May 17, 2006
JAFF-06-0079

**SUBJECT: James A. FitzPatrick Nuclear Power Plant
Docket No. 50-333
Response To NRC Request for Additional Information
Regarding FitzPatrick's Proposed Exemption Request
For Hemyc Fire Wrap (TAC No. MC7995)**

Attachment 1 to JAFP-06-0079
Entergy Nuclear Operations, Inc. – FitzPatrick
Docket No. 50-333
Response to Request for Additional Information (RAI)

(Structural Support Layout)
 Page 1 of 2

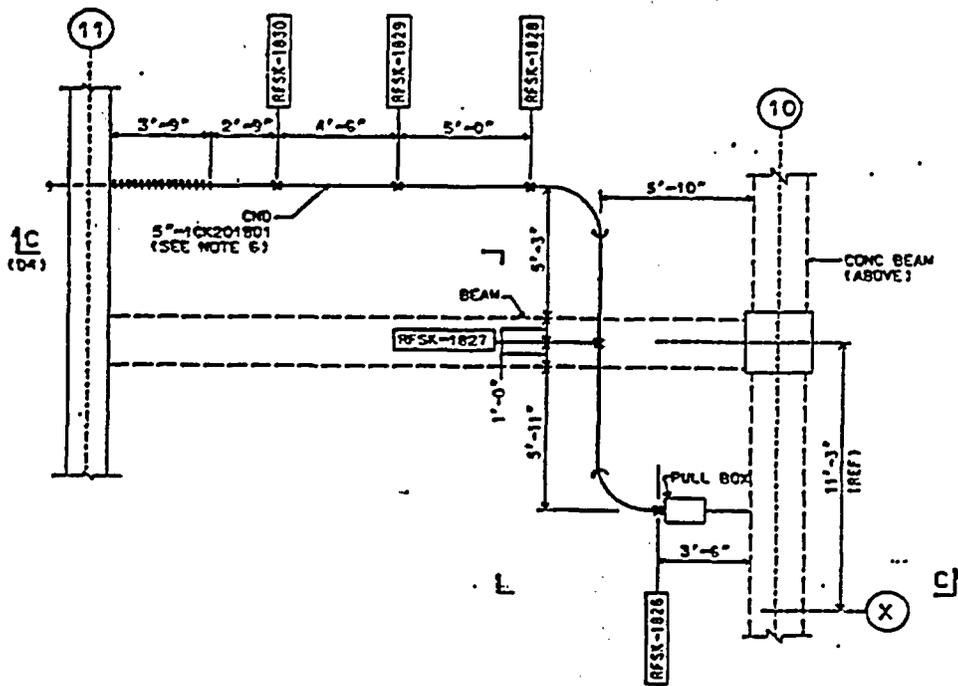
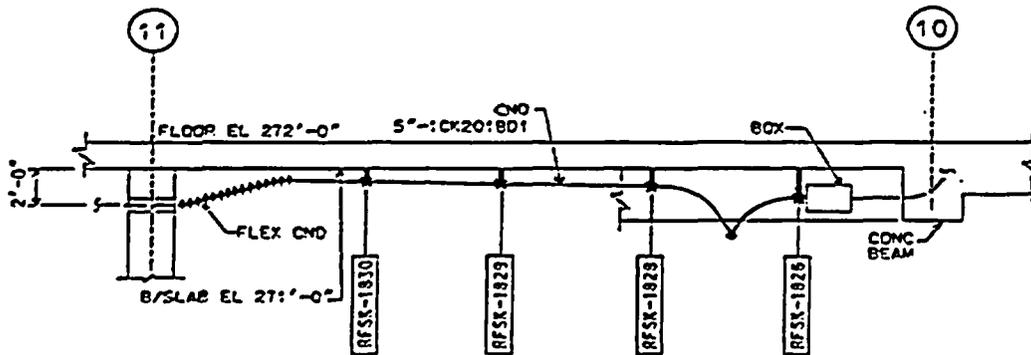
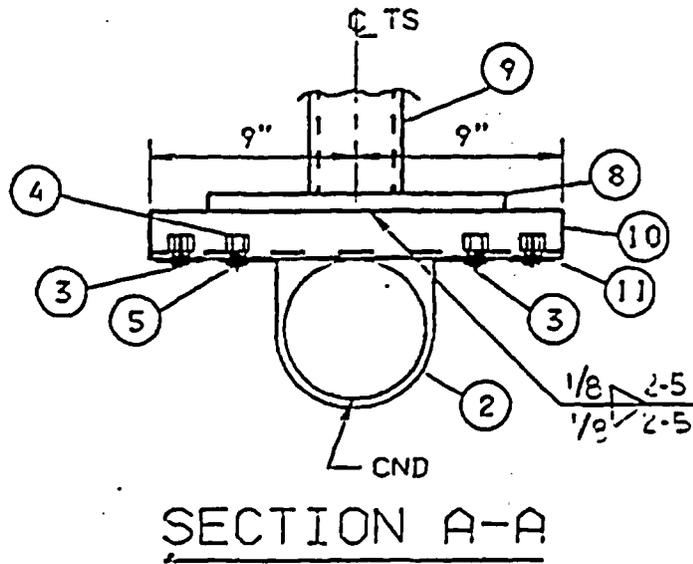
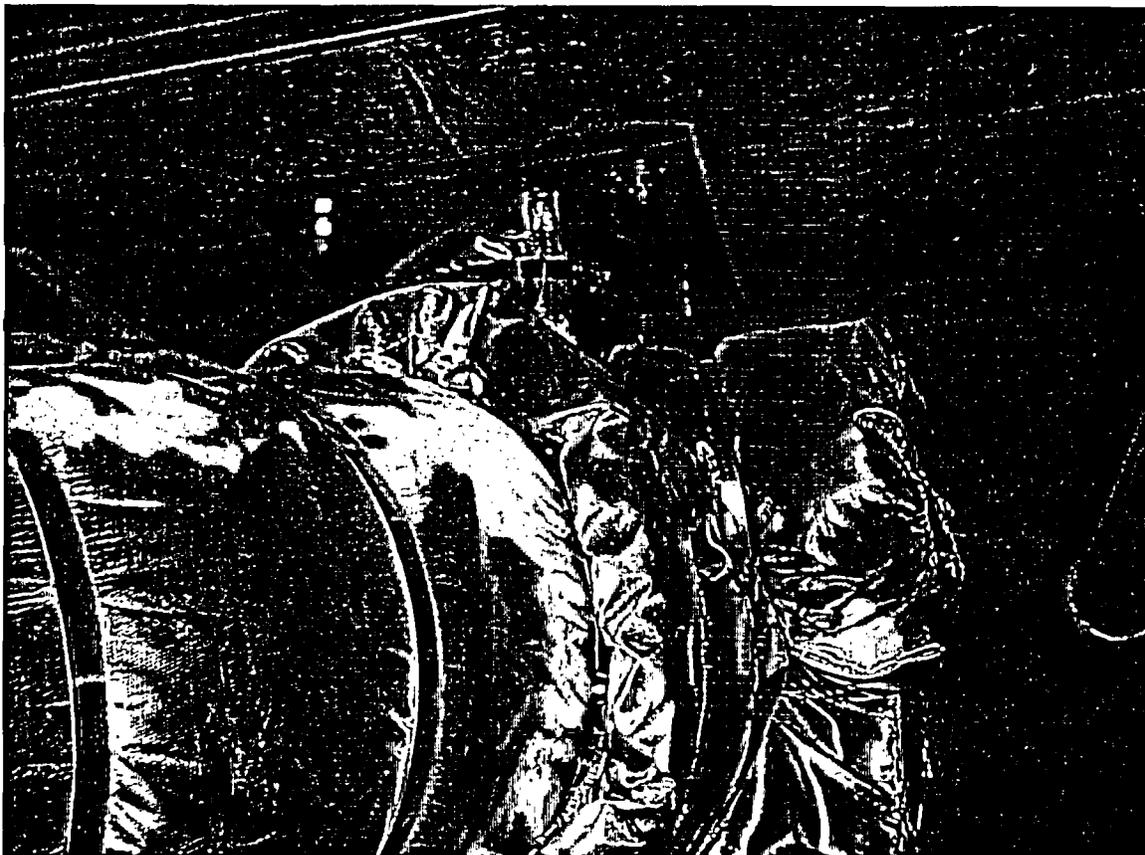
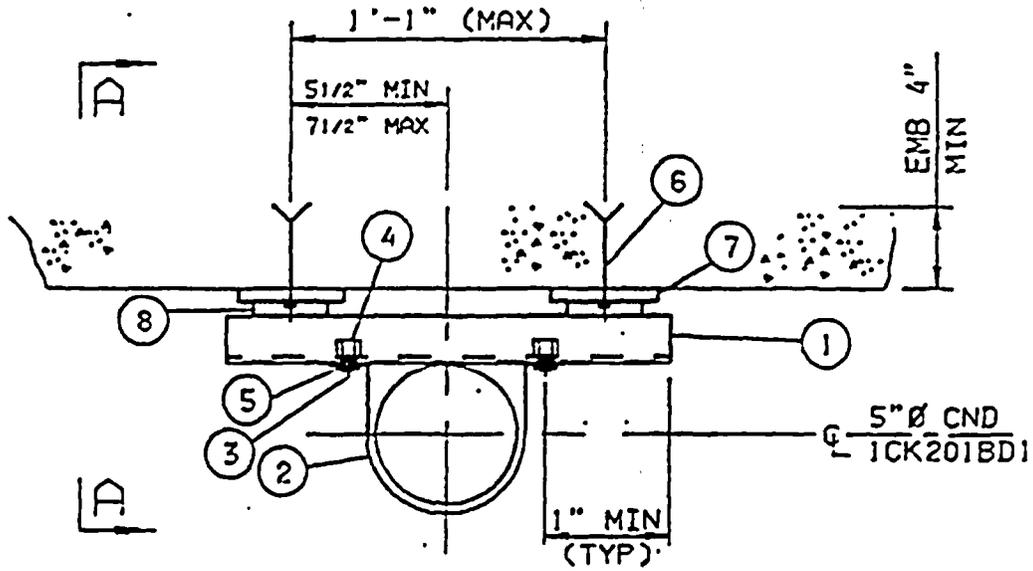
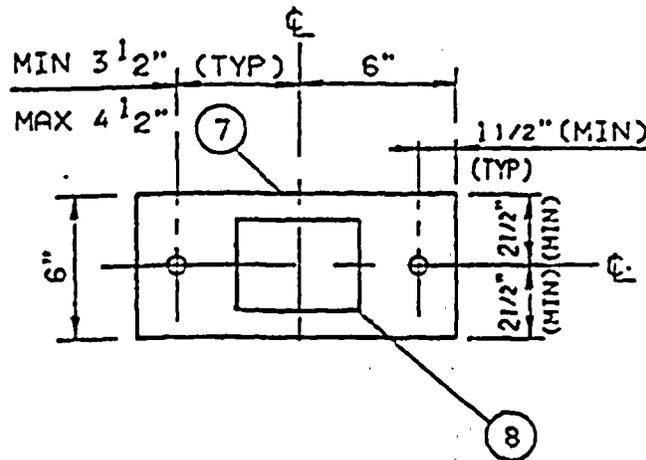
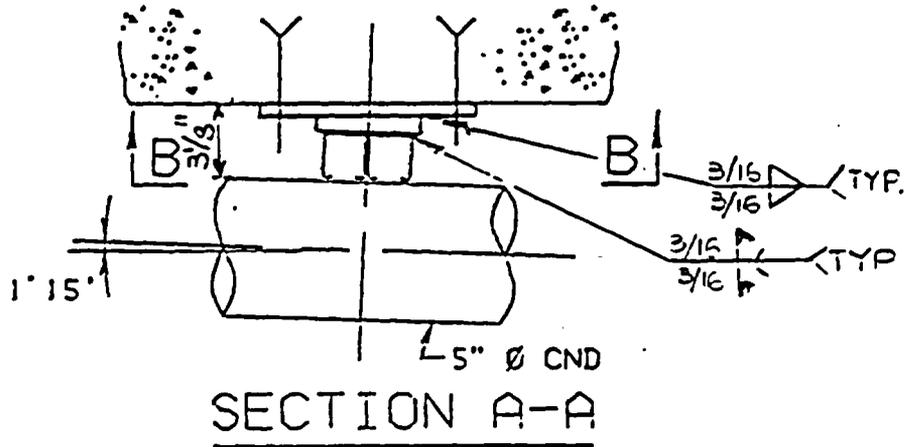
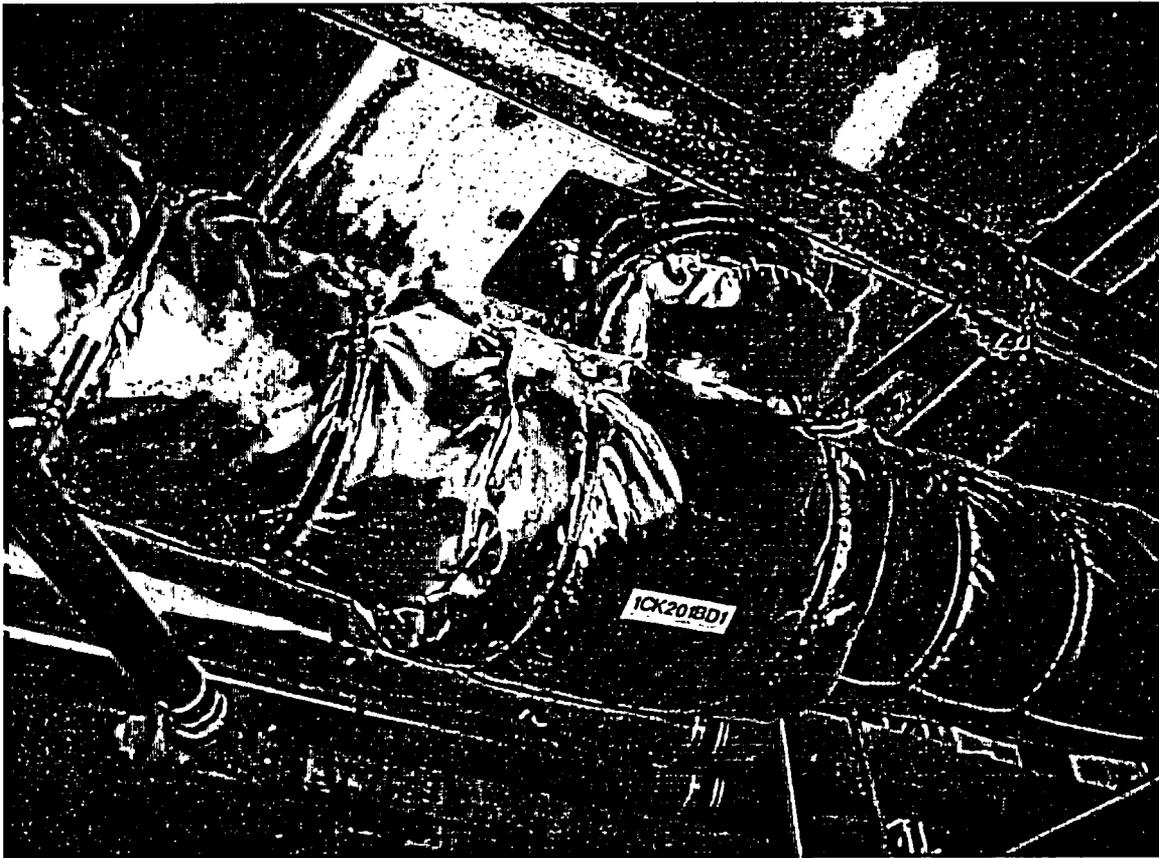
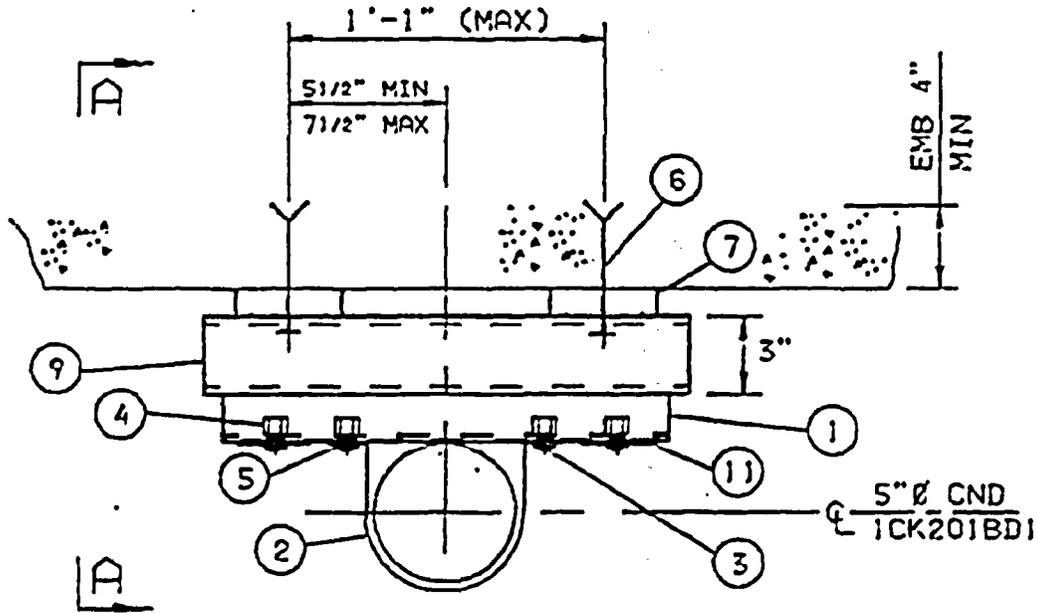
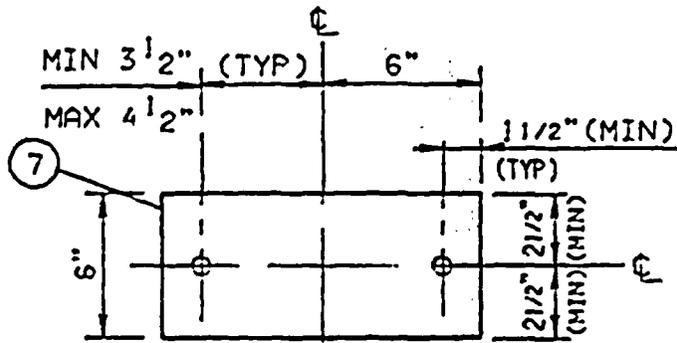
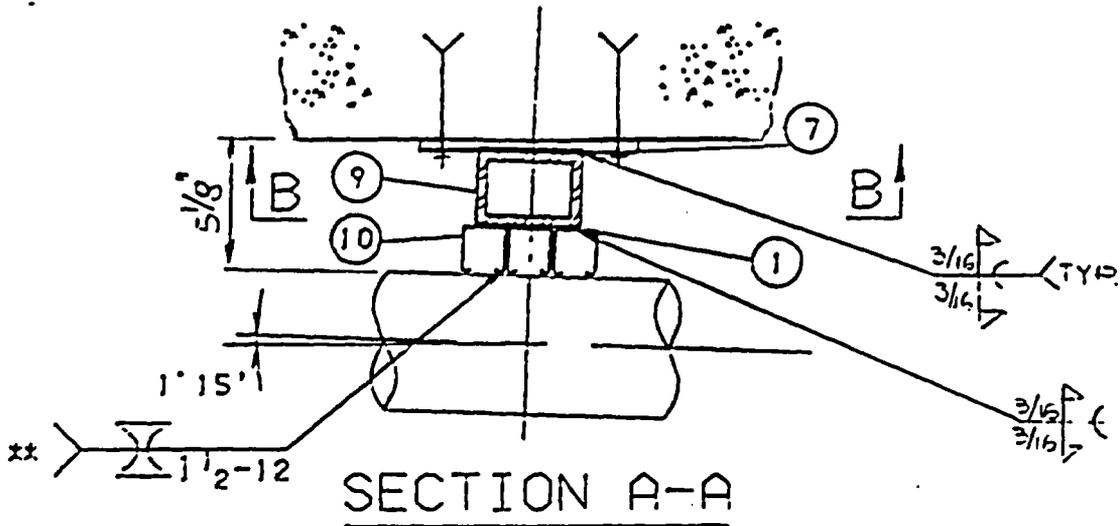
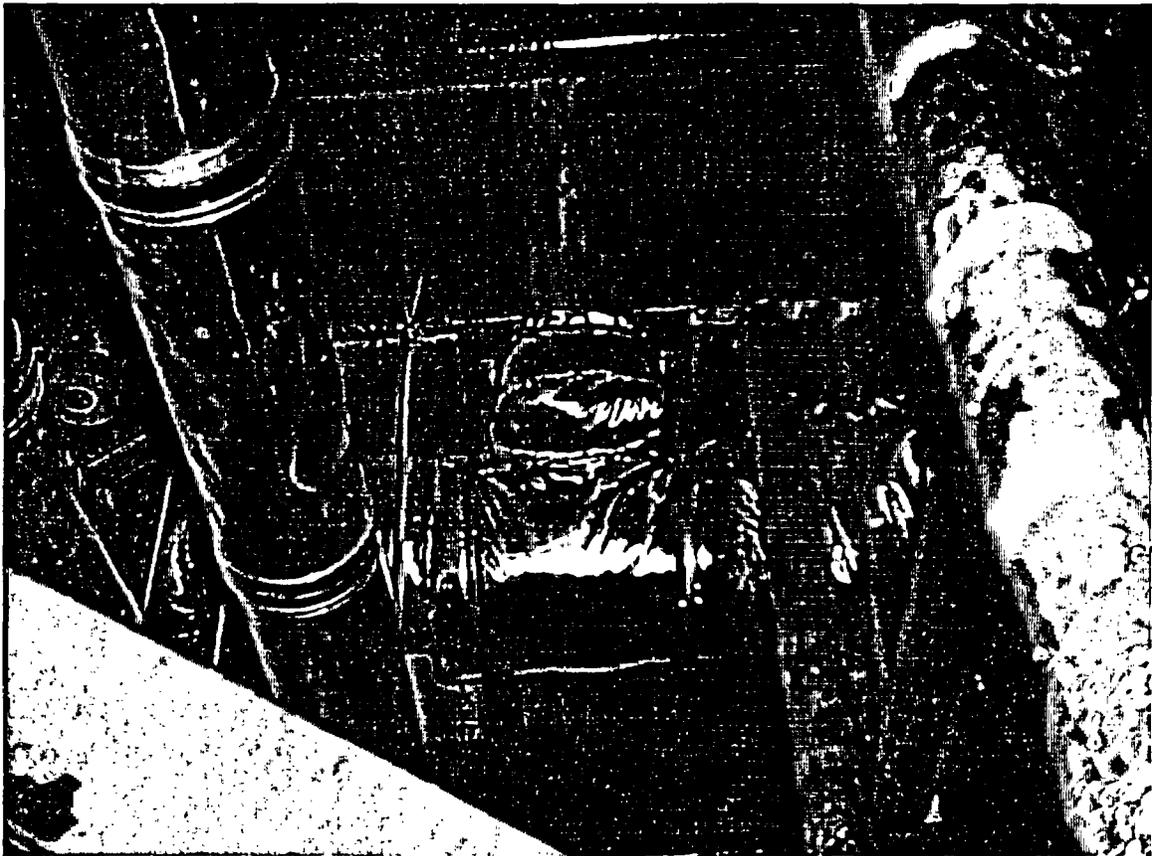
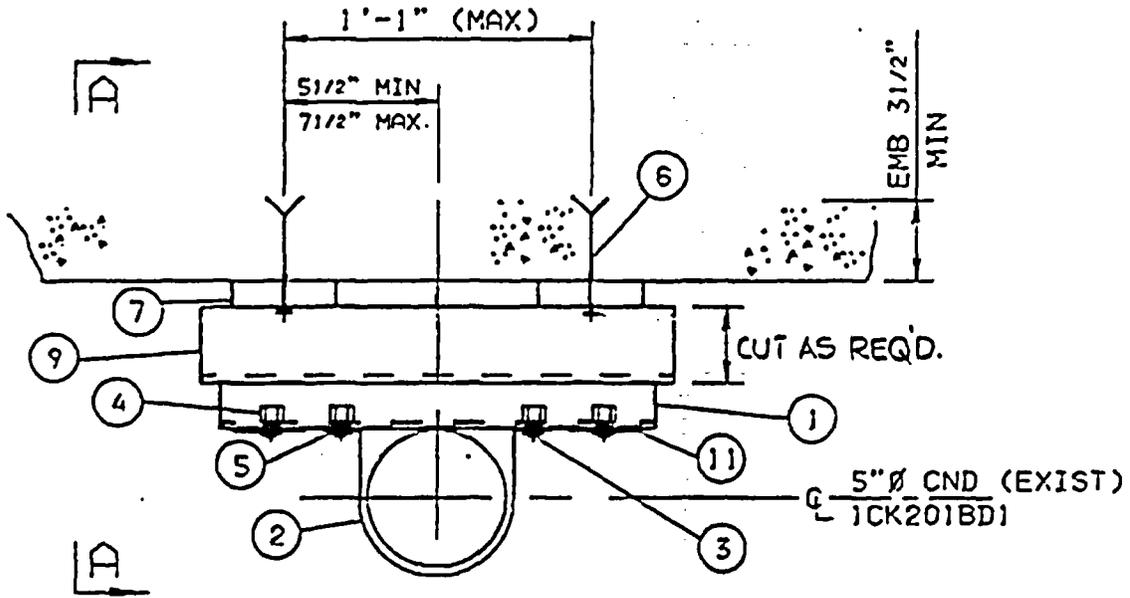
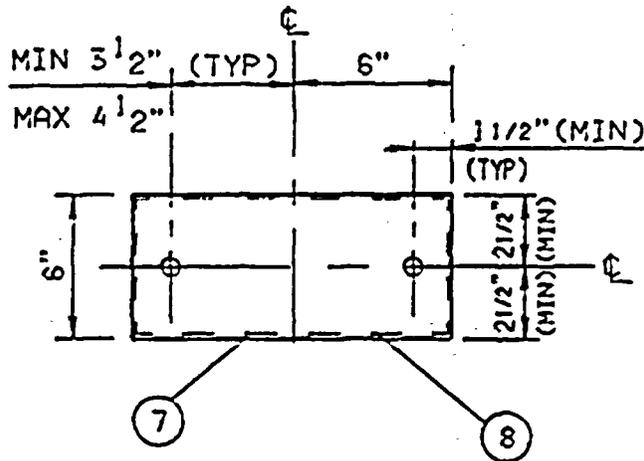
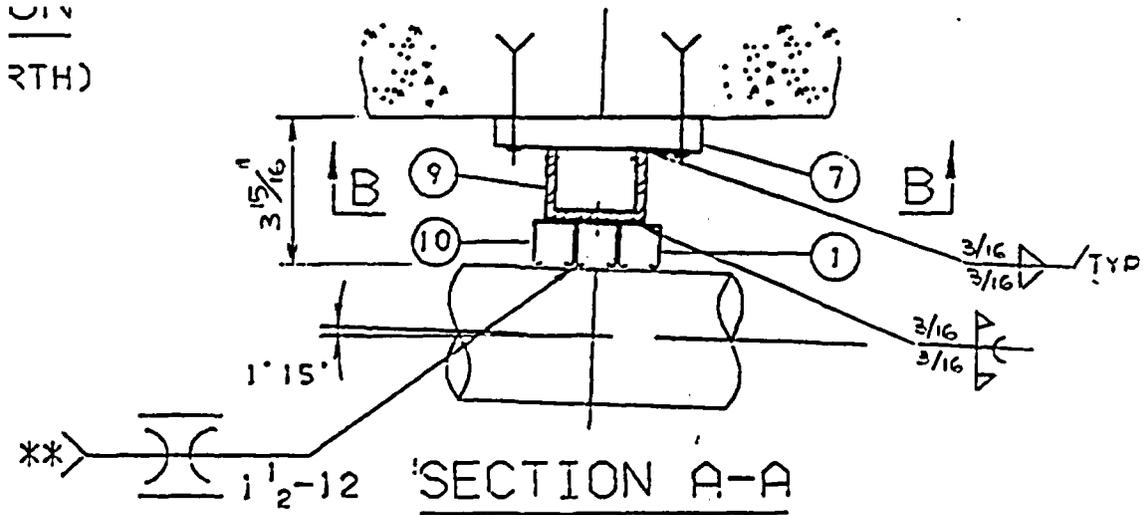
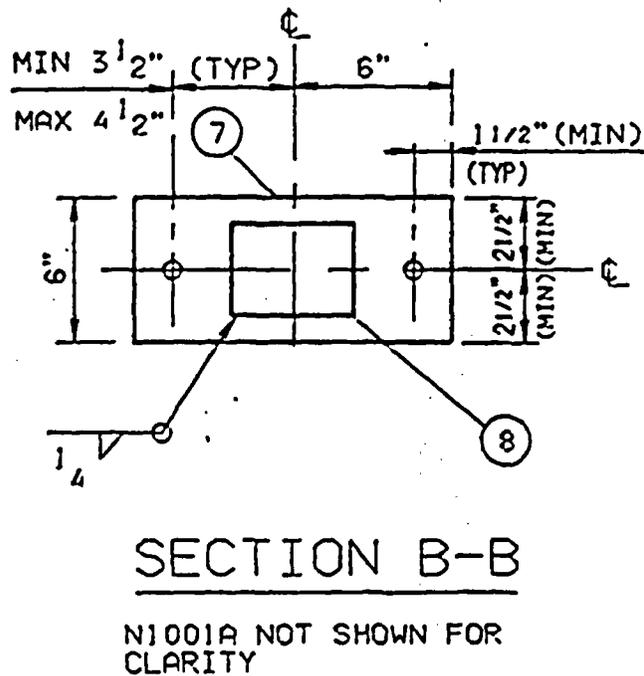
The submittal describes Hemyc wrapped structural supports. Steel supports were tested by the NRC separately from the conduit and found to fail as early as 13 minutes into the event. The additional heat load transferred to the conduit by the steel supports was not considered in the conduit tests. The FitzPatrick configuration is described as including five structural supports, completely wrapped except for a portion of the base plate. How has it been determined that the heat transfer from the exposed base plate would not adversely affect the protected cable? In the event of a fire, what would be the impact of heat transfer from the uncovered base plate through the supports to the conduit? In responding to these questions, please include the distance from the baseplate to the conduit containing the cable, and quantify the distance into an hourly rating using the NRC testing for similar supporting structures (angle iron, unistrut). Please also include the area of the base plate that is uncovered.

The structural support base plates are described as mounted in place with Hilti bolts to the concrete ceiling. Are these bolts covered by fire wrap? In the event of an intense fire, could concrete spalling compromise the ability of these bolts to function? If not, why not?

The effects of heat transfer from the exposed base plate have been evaluated based on a comparison of the JAF structural support configuration with the results of testing performed by the NRC, and engineering judgment.

The JAF structural support configuration utilizes multiple pieces of unistrut horizontally mounted to steel spacers. The spacers consist of square tube steel, steel plate, or “C” channel mounted to base plates which are mounted to a concrete ceiling with Hilti Kwik Bolt II anchor bolts. The steel support members attached to the base plates are entirely wrapped with Hemyc which results in most of the base plate being covered. The area of the base plates that is uncovered

varies, but is roughly the outer 2 inches on either end of the 6 inch by 12 inch plates, and roughly the outer 2 ½ inches on the exposed perpendicular edges and approximately 5 inches exposed at the corners of the 12 inch by 12 inch plate. The distance between the uncovered base plate and the conduit containing the cable is just over 5" for the limiting case. This was determined for support RFSK-1827, considering a linear distance from the uncovered base plate, across the wrapped portion of the base plate, the solid steel spacers, the double unistrut to the point where the conduit with the cable makes contact with the unistrut. See Attachments 3 through 8 for diagrams and photographs of the Hemyc wrapped supports.

The supports tested by the NRC consist of a single run of unistrut and tube steel cut and welded into an "L" shape. By interpolating the thermocouple data contained in the NRC test, the unistrut support would meet a 30 minute temperature rating (single point temperature increase of 325°F above ambient) at less than 4 inches in from the exposed end and the tube steel would meet a 30 minute temperature rating at approximately 6 inches in from the exposed end.

Based on the differences described, no direct comparison could be made between the NRC test results and the JAF configuration. However, in the event of a fire, it is reasonable to expect that given the location of the base plate and its mounting to a concrete ceiling, that the concrete would absorb much of the heat absorbed by the base plate. This absorption would result in less heat transfer along the support members to the protected conduit containing the cable. In this configuration, the concrete ceiling would function as a heat sink. In addition, given the thermal mass of the JAF support configuration that is protected, in comparison to that tested by the NRC (greater than double by observation), it is expected that a greater amount of heat would be required to raise the temperature of the steel support within the wrap, thus resulting in lower overall temperatures at 30 minutes. This is reasoned because there were no attachments to the simple unistrut and tube steel supports tested by the NRC, and heat transfer along the steel member progressed without heating adjacent structural members.

Based on the information presented above, the supports would be expected to provide at least a 30 minute fire rating. However, based on the fact that: (1) there are virtually no fire hazards in the area of the conduit, with the exception of fire retardant cables; (2) the area is protected by a full area wet pipe sprinkler system; (3) complete in tray wet pipe water spray system; and (4) full area fire detection, the potential to have an unmitigated fire substantial enough to challenge the integrity of the protected cable is non existent.

The Hilti Kwik Bolt II bolts used to secure the structural supports in place are not entirely covered by the Hemyc fire wrap as seen in the attached photographs. At the time the Hemyc wrap was installed, the need to wrap the base plates and Hilti bolts was evaluated using the guidance contained in NRC Generic Letter 86-10 (Reference 6) and it was determined that wrap was not required.

In accordance with option (b) above, this area is equipped with automatic area fire detection, automatic general area suppression and an automatic cable tray suppression system. The area is also equipped with fire hose stations and portable fire extinguishers in the immediate proximity. As discussed in the exemption request (Reference 4), the combustible loading in the area is composed primarily of fire retardant cables which pose a minimal fire hazard. In addition, ignition sources are negligible.

If a fire should occur, the early warning detection system would actuate and transmit an alarm to the control room. Upon confirmation of the fire, the fire brigade would be immediately dispatched to the area and would suppress the fire using available hose stations and/or portable fire extinguishers. If a rapid temperature rise were to occur prior to the arrival of the brigade, the automatic area suppression system would actuate to control and/or extinguish the fire, reduce the area temperature, and thus preclude the potential for support failure or significant concrete spalling. Considering the existence of the fire protection features in the area, it was determined that the exposed base plates and Hilti bolts were acceptable (Reference 7), even when the Hemyc wrap was considered to provide a 1 hour fire rating.
